Staff Report

To: Salt Lake City Planning Commission
From: Daniel Echeverria, 801-535-7165, Daniel.echeverria@slcgov.com
Date: August 3, 2018
Re: PLNPCM2018-00323, The Fairmont Conditional Building and Site Design Review

Conditional Building and Site Design Review

REQUEST: A request by Alex Lowe, representing the property owner Fairmont Apartments LLC, to build a 59 residential unit mixed use building. The property is located in the CSHBD-2 (Sugar House Business District-2) zone which requires buildings over 30 feet in height to go through the Conditional Building and Site Design Review (CBSDR) process. As the building is approximately 60 feet in height it is subject to the CBSDR process.

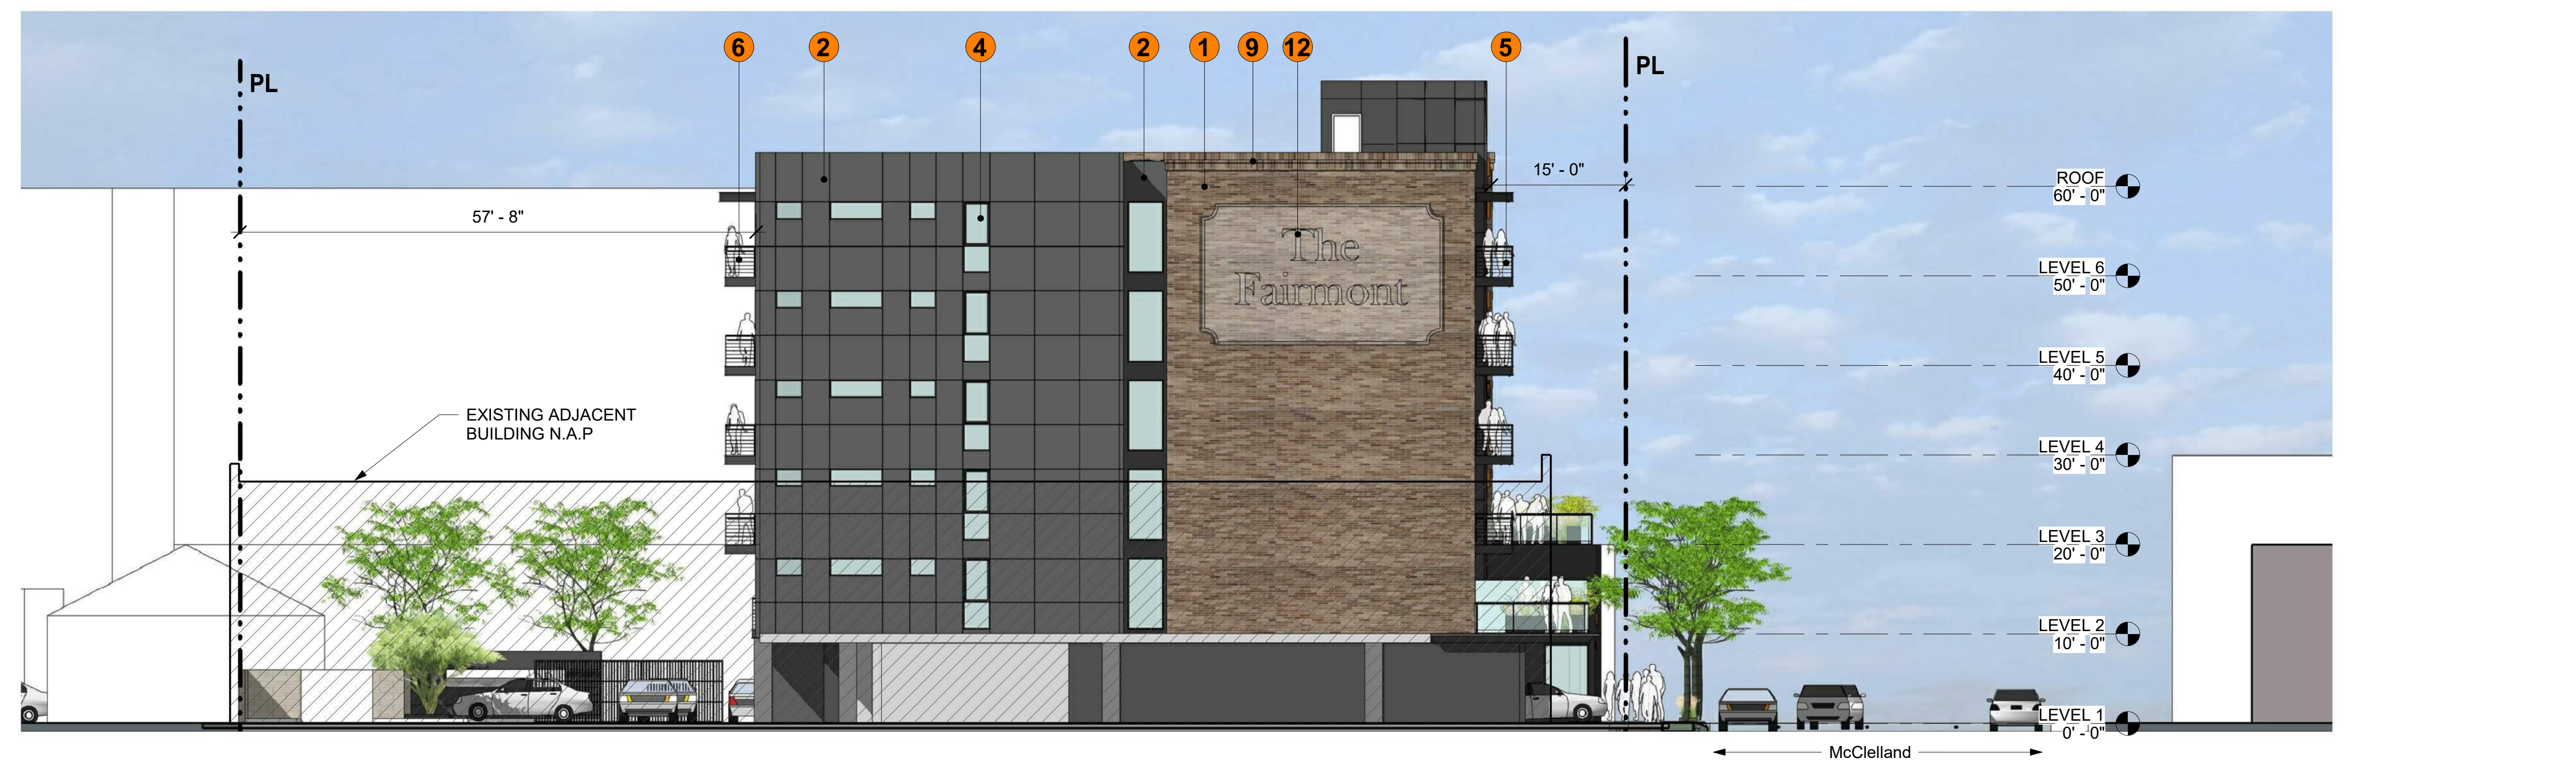
The *Sugar House Business District Design Guidelines* includes a specific policy about 360 degree architecture: “Avoid facade architecture: all faces of the building should be designed with similar detail and materials.” The initial iteration of this development proposal provided architectural detailing on the rear (west) facade, but generally did not incorporate brick into the rear facade. Instead this facade was covered by stucco. The rear facade thus appeared to be a far different architectural style due to the difference in material choice as compared to the street facing facades that are nearly 100% brick and glass.

Staff recognizes that the developer is using a very high amount of brick on the front facade- far more than other recent Sugar House developments that have utilized other materials such as stucco, EIFS, or fiber-cement board to reduce the amount of brick on their street facing facades. However, staff felt that because of the high visibility of the rear facade from adjacent property and public streets (due to its ~40 setback), the development should incorporate brick into the rear facade in some fashion to create a more cohesive 360 degree product and link the rear face to the street facing facades.

In response to those concerns, the developer has revised the rear facade design by interspersing brick columns along that facade with window treatments and cornice details similar to the front facades, and increasing the window sizes to significantly reduce the amount of stucco on that facade. Overall these

changes better tie the rear façade to the public facing facades, and while increasing the brick on the rear façade, they have retained the original high level of brick on the street facing facades. Staff believes that the high level of brick on the front facades warrants some leeway on the rear façade regarding the 360 degree architecture guideline and believes that the level of brick and glass on the rear façade is an acceptable compromise that still substantially links the architectural design of the rear façade to the other street facing facades.
